RE: Other County Requirements (Addendum to Geotechnical Plan)

# COUNTY OF SAN DIEGO TRACT NO. TM 5223 RPL-3

## SHADOW RUN RANCH, PAUMA VALLEY

### PRELIMINARY GRADING PLAN

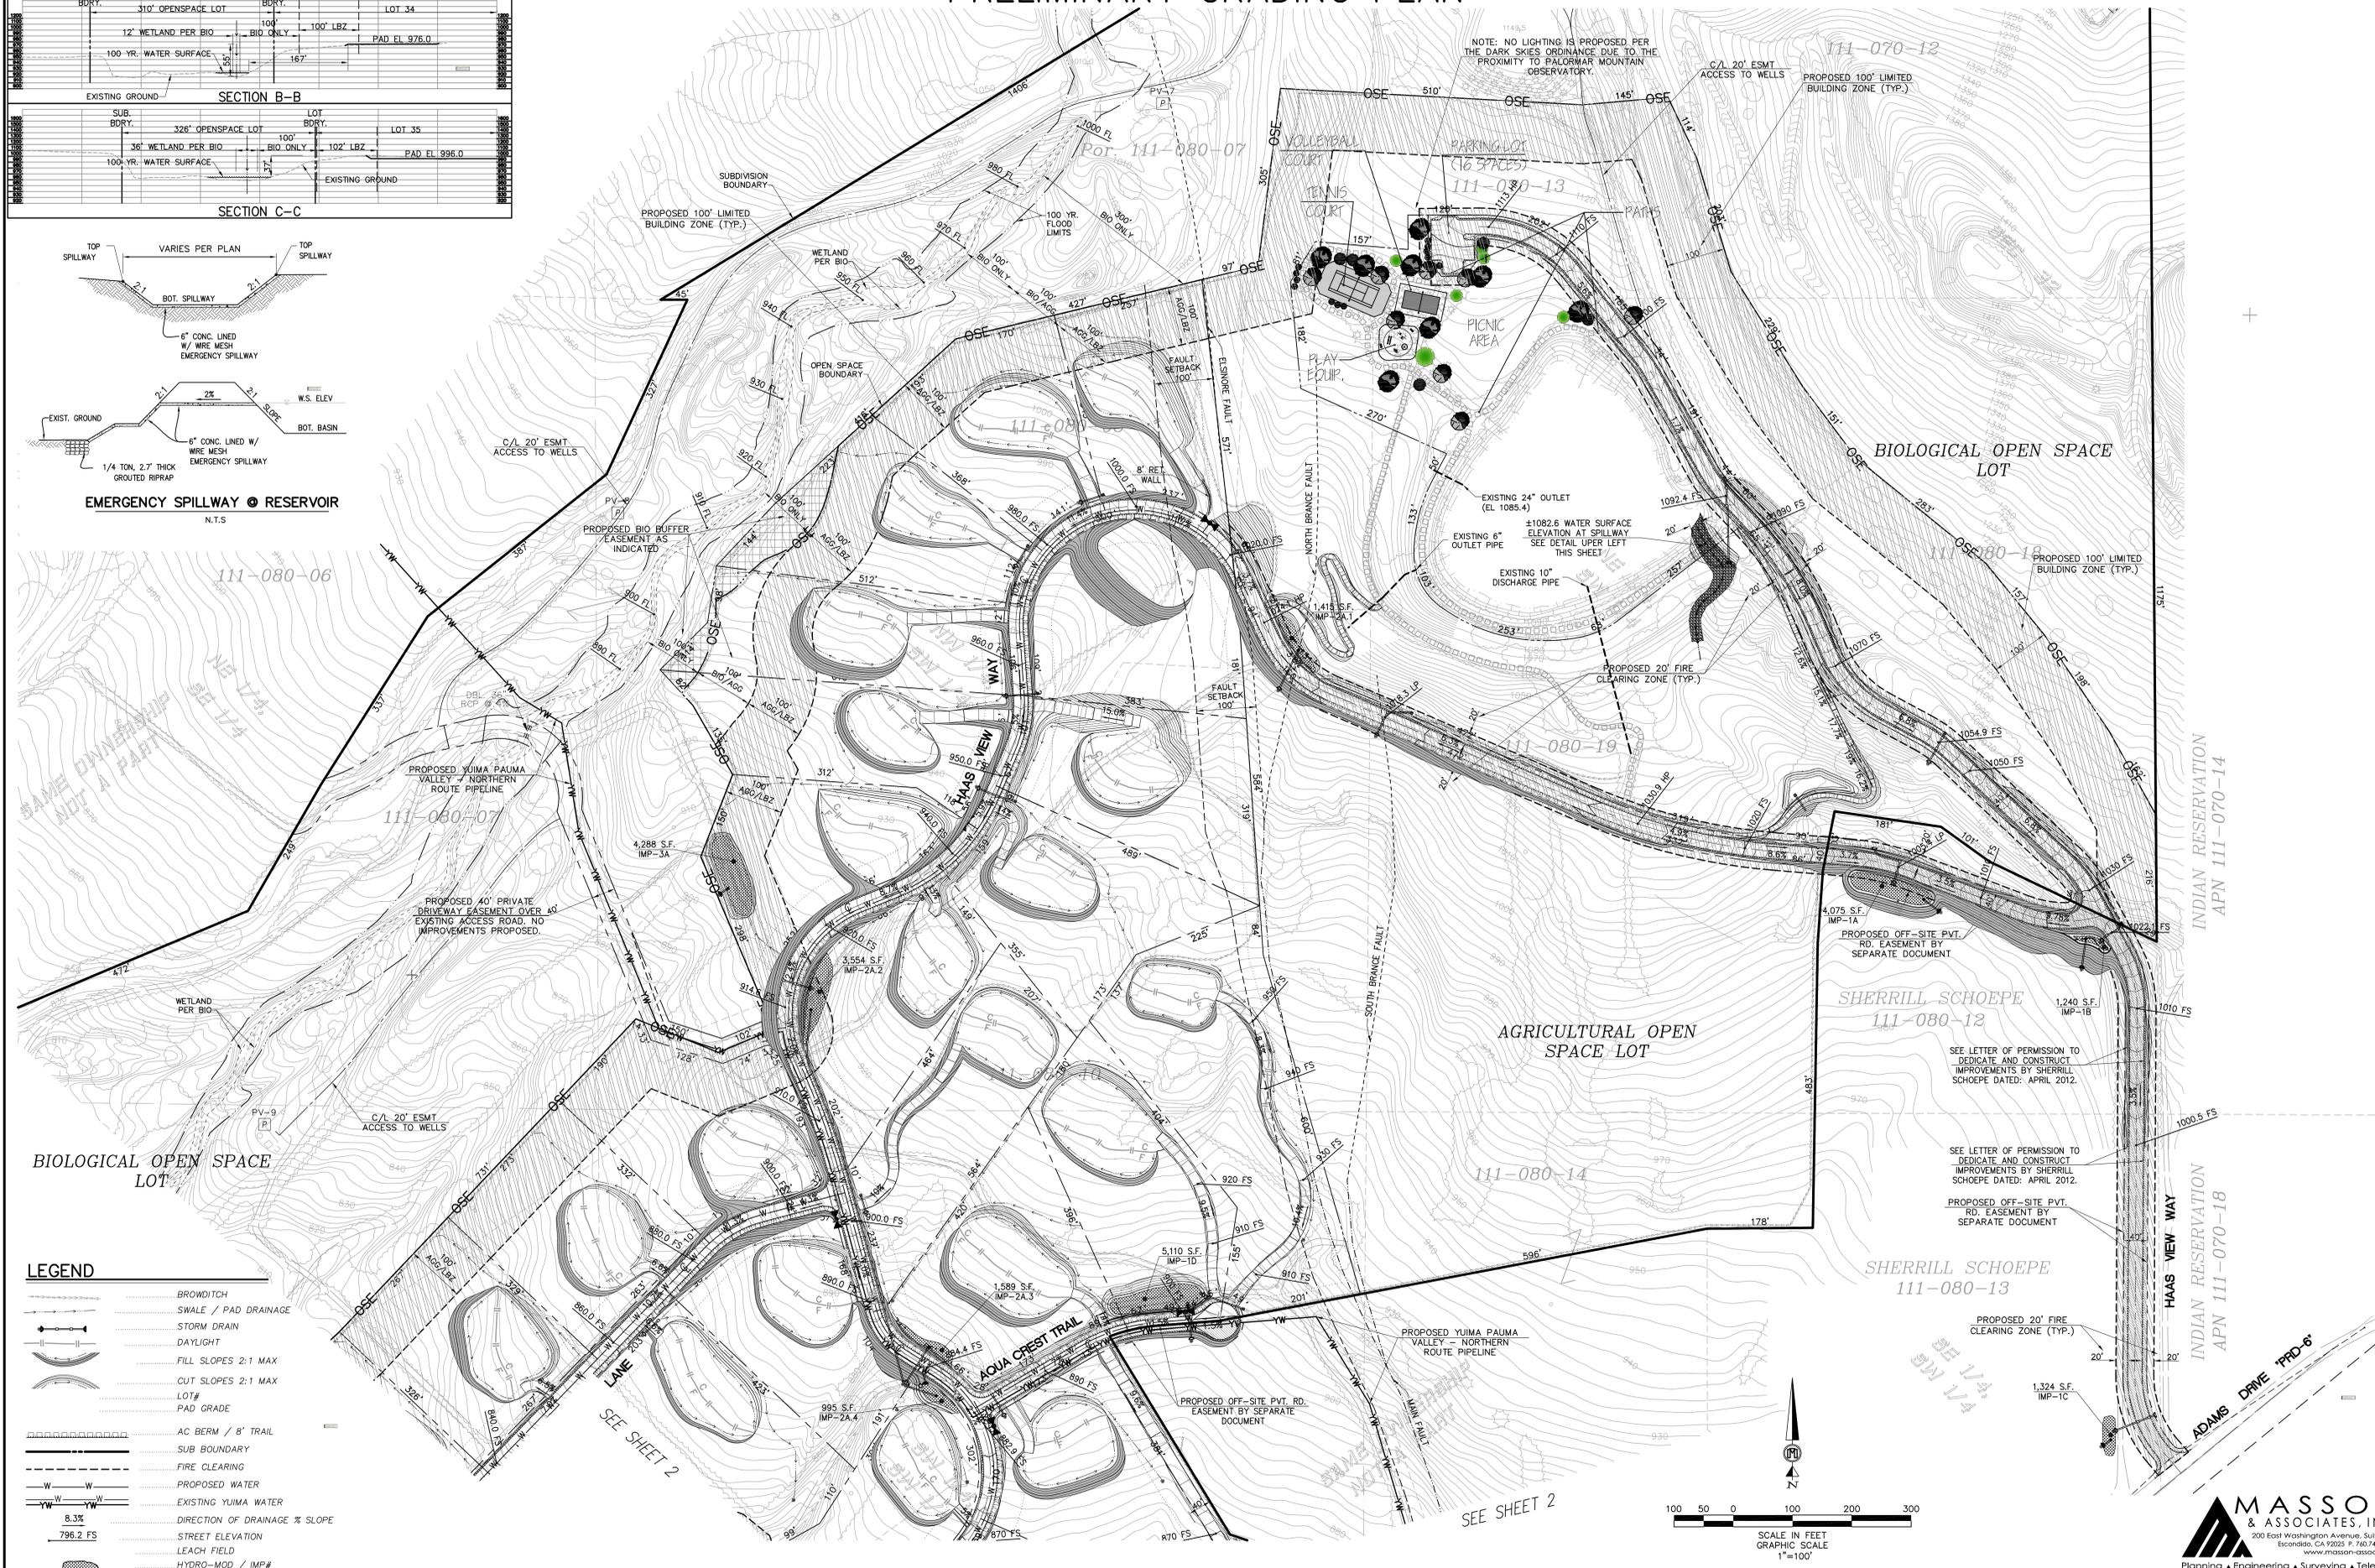
1. Relocate reservoir spillway
2. Reservoir drainage (1000 yr flood calcs)
3. Reservoir overtopping (seiche overtopping - short term concentrated flows)
4. Failure analyses including path and limits of inundation (in the event of a reservoir embankment failure).
5. Detailed maintenance plan to control deterioration due to erosion, vegetation, and small animals.
6. Emergency drawdown calculations

- Item 1: See revised preliminary grading plan moved spillway (Attachment 1)
- Item 2: See additional drainage 1,000 yr. calculations (Attachment 2)
- Item 3: Previously addressed in May 31, 2013 letter submitted by Masson & Associates Inc. (Attachment 3)
- Item 4: With regard to the worst case scenario of failure, by piping, we reference the URS letter dated August 22, 2013 "Work plan for Geotechnical Assessment" which indicates failure and inundation analysis is not required at this time.
- Item 5: See Operation & Maintenance Plan (Attachment 5)
- Item 6: See Emergency drawdown calculations (Attachment 6)
